GEN-2017-047 Modification Request Impact Study

Revision R1 August 6, 2024

Submitted to
Southwest Power Pool

Figure 2-2: GEN-2017-047 Single Line Diagram (Modification Configuration)

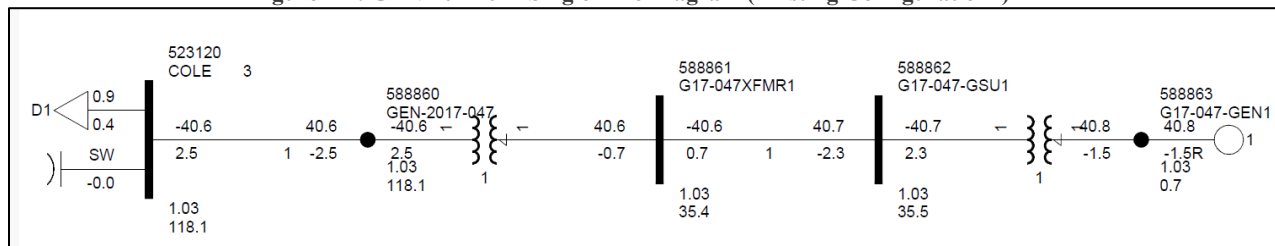
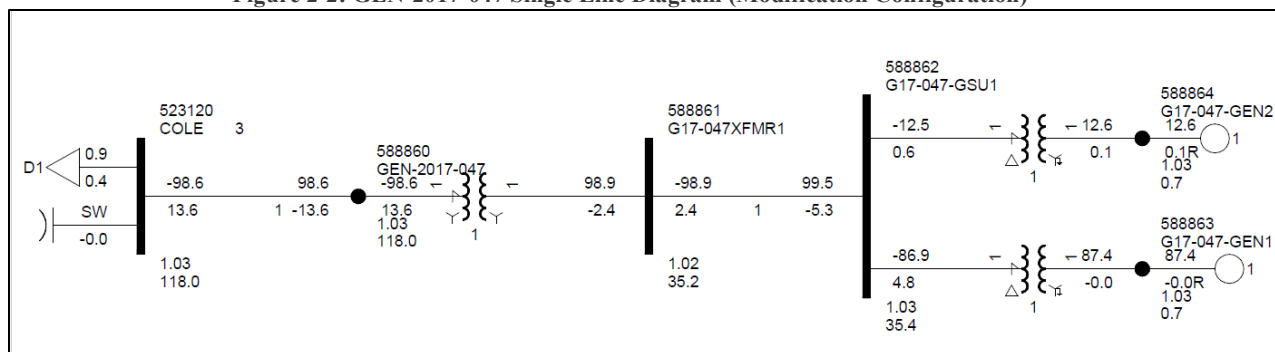
The GEN-2017-047 project is currently in the DISIS-2017-001 cluster. Figure 2-1 shows the power flow model single line diagram for the existing GEN-2017-047 configuration using the DISIS-2018-002/2019-001 25SP stability model.

This Study has been requested to evaluate the modification of GEN-2017-047 to change the configuration to 31 x GE 2.82 MW + 5 x GE 2.52 MW wind turbines for a total dispatch of 100.02 MW

In addition, the modification request included changes to the collection system, generator step-up transformers, main substation transformers, and generation interconnection line. Figure 2-2 shows the power flow model single line diagram for the GEN-2017-047 modification. The existing and modified configurations for GEN-2017-047 are shown in Table 2-1 below.

Figure 4-1: GEN-2017-047 Single Line Diagram (Shunt Sizes)

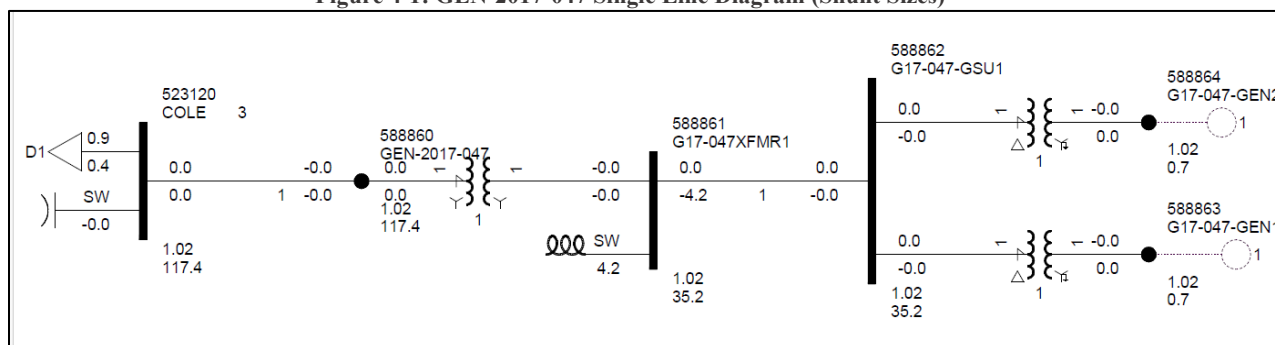
The results from the analysis showed that the GEN-2017-047 project needed approximately 4 MVar of compensation at its collector substation to reduce the MVar injection at the POI to zero. This is an increase from the 1.67 MVar found in the DISIS-2017-001-2 study³. The final shunt reactor requirements are shown in Table 4-1. Figure 4-1 illustrates the shunt reactor size needed to reduce the POI MVar to approximately zero with the updated topology.
